## Chatham County Planning Board Agenda Notes

**Date: June 6, 2023**

<b>Subject:</b>	Request by Chad Abbott, P.E. on behalf of Lovin Spoonful, LLC for subdivision Concept Plan review of Ridgecrest Subdivision, consisting of 28 lots on 49.41 acres, located off Hamlet Chapel Road (SR-1525), parcel 1798 in Baldwin Township.
<b>Action Requested:</b>	See Recommendation
<b>Attachments:</b>	<ol style="list-style-type: none"> <li>1. First Plat titled 'First Plat Ridgecrest Estates', prepared by C3 Design &amp; Engineering, PLLC</li> <li>2. Ridgecrest Estates Subdivision Adjacent Property Owner List</li> <li>3. Major Subdivision Application and Authorized Agent for Legal Representation Form.</li> <li>4. Location map</li> <li>5. Comments from Chatham County Historical Association</li> <li>6. Notification to Chatham County Schools</li> <li>7. Copy of General Environmental Documentation and approval letter dated October 19, 2021.</li> <li>8. US Army Corp. of Engineers Notification of Jurisdictional Determination dated June 30, 2021</li> <li>9. Copy of Community Meeting Report Form dated March 3, 2021</li> <li>10. Technical Review Committee Comments</li> <li>11. Detailed Soil Scientist Report

**Current Proposal**

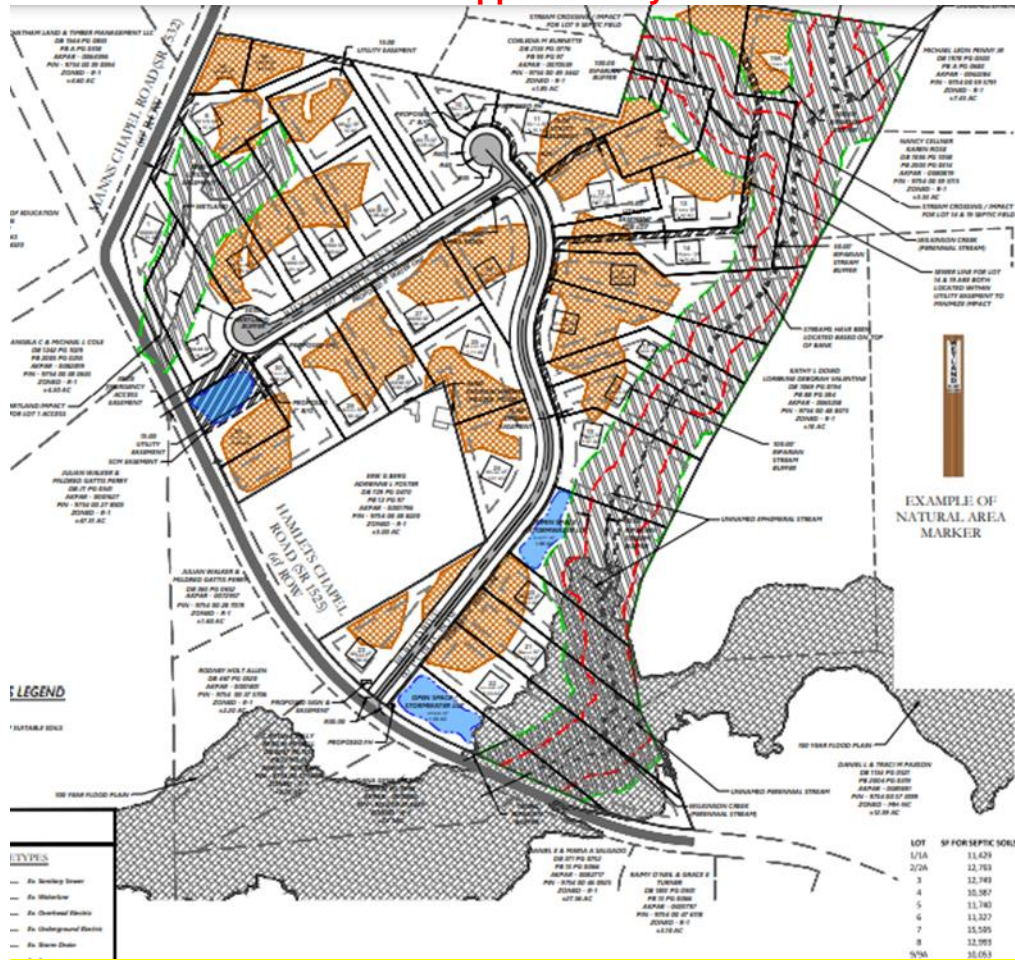
The proposed project layout was decreased by two lots, shed encroachments from the Berg property have been resolved, and no proposed stream crossing for septic.

- The Utility Dept. requested the fire hydrant to be located near Lot 25, a fire flow test is needed, and asked what size water line will be proposed. Mr. Abbott sated 8-inch water line.
- The Watershed Protection Dept. had concerns about lots 2-4 not having enough room for homesite, suggested to move the access easement to the stormwater pond to between Lots 1 and 2, and remove the Wilkinson Creek labeling that goes through Lots 14 and 15.
- Road name was approved by Emergency Operations.
- Show cul-de-sac radius on the plat.
- NCDOT stated that in the future they would like to see the rolling terrain design criteria used in this area and they thought the mountainous terrain criteria may have been used.
- Lot 1 septic easement will be located on the Berg property, and this will require Berg to sign the final plat and sign the first plat application.

**Encroachment:** Parcel 1796 currently has shed encroachment on proposed Lot 28. The developer has worked with the owner of parcel 1796 about the shed encroachment and both agreed to exchange properties. The new lot lines will place the sheds inside parcel 1796 and the sheds will meet the minimum zoning setbacks. The recombination will be completed at the time of filing the final plat.

The Planning Department recommends granting approval of the road names Ridgecrest Estates Drive and Gattis Way Court and granting approval of subdivision First Plat for **Ridgecrest Estates** with the following conditions:

1. Approval of the First Plat shall be valid for a period of twelve (12) months following the date of approval by the Board of Commissioners and the Construction Plan approval shall be valid for a period of twenty-four (24) months from the date of approval by the Technical Review Committee or Board of Commissioners.
2. The county attorney shall review and approve the contract and performance guarantee prior to final plat recordation.
3. Property owner(s) of parcel 1796 shall sign the final plat prior to recordation.
